Access Compliance Report Public Rights-of-Way (Curb Ramps)

Main Street: BRIOSO_ST Cross Street: BRIOSO_ST Location: NW

ADA ID: RPRK211118124525 Ramp Type: Type 1 - Perpendicular Initial Pass/Fail: Pass Overall Compliance: No Severity Score: 5

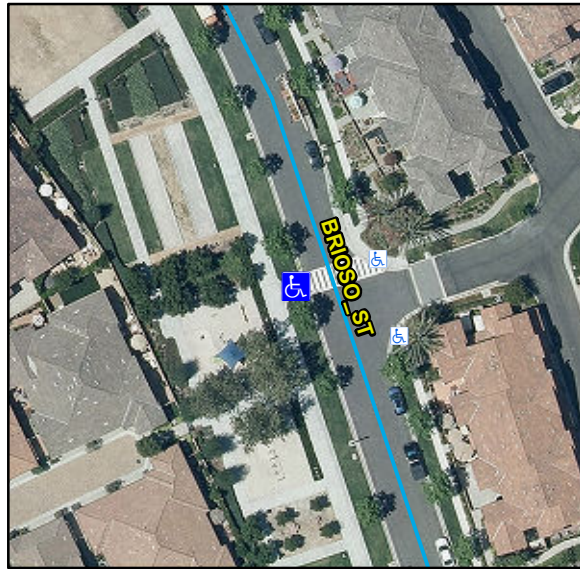
Yes	Ramp Inside Crosswalk 1	Yes	Yes	Ramp Inside Crosswalk 2	N/A
	Crossing 1 Slope (%)	3.1		Crossing 2 Slope (%)	N/A
	Crossing 1 Cross Slope (%)	0.8		Crossing 2 Cross Slope (%)	N/A
Yes	Gutter Ponding	No	No	Curb Slope	8.5
Yes	Gutter Lip Height (in)	0		Road Run Slope (%)	N/A
No	Gutter Run Slope (%)	8		Road Cross Slope (%)	N/A
Yes	Gutter Cross Slope (%)	0.1			
Yes	Overall Surface Condition: Acceptable		Yes	Perp Joint Present	Yes
	Cross Gutter Present?	No		Spandrel Present?	No
	Replace Cross Gutter?	N/A		Replace Spandrel?	N/A

Remove & Replace Curb Slope. Remove & Replace Gutter.
